***Install New 230 kV Disconnect Switches on M20D & M21D at Preston TS
Notification of Conditional Approval of Connection Proposal
CAA ID# 2010-EX514***

Final Report - Expedited System Impact Assessment Hydro One Networks

Figure 1 – New disconnect switches on M20D-M21D at Preston TS

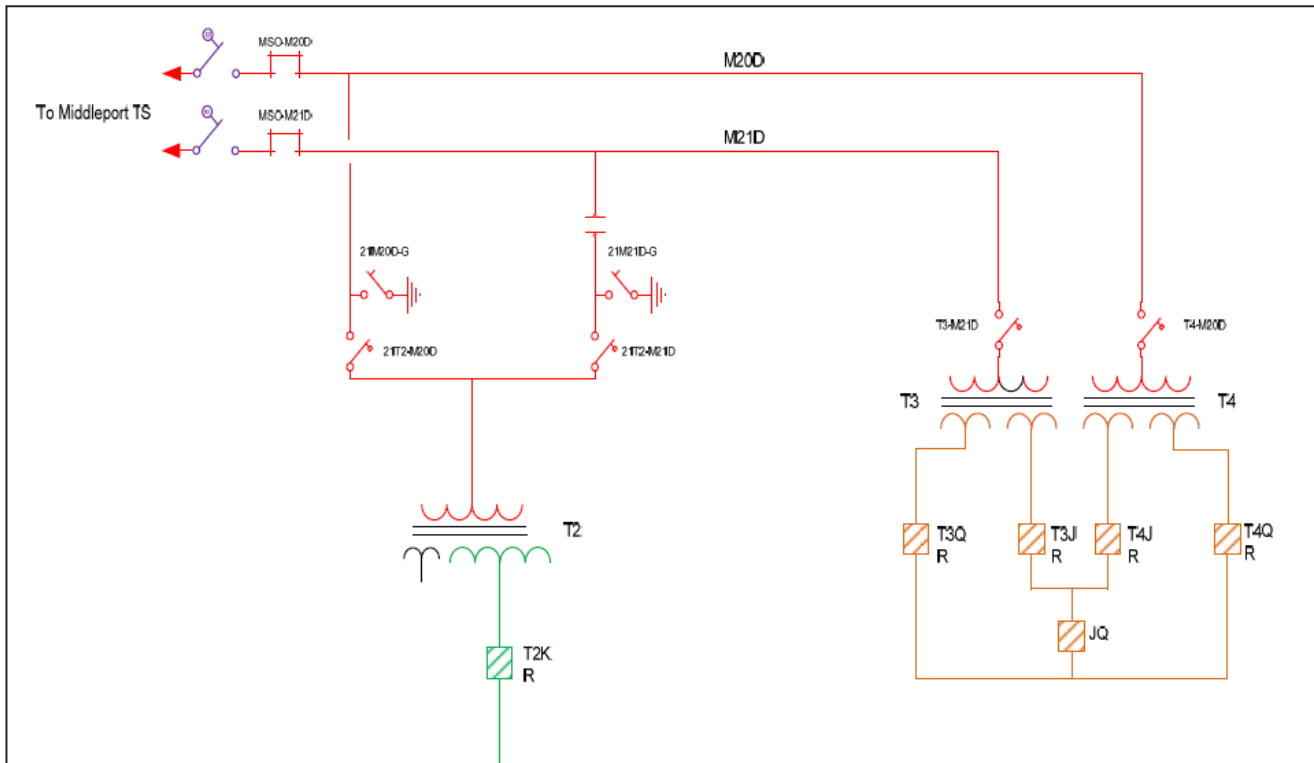
Hydro One is planning to install motorized air-break disconnect switches on the 230 kV circuits M20D and M21D at Preston TS to meet the IESO's criteria to restore power in the event of a contingency. These disconnect switches will be used to isolate autotransformer T2 and the DESN transformers T3 and T4 at Preston TS from M20D-M21D. Some load can then be restored via autotransformer T2 within the 30 minutes specified by the Ontario Resource and Transmission Assessment Criteria document.

The proposed configuration is shown below in figure 1.

This expedited System Impact Assessment concludes that the installation of the new disconnect switches on M20D-M21D at Preston TS is not expected to have a material adverse impact on the IESO-controlled grid.
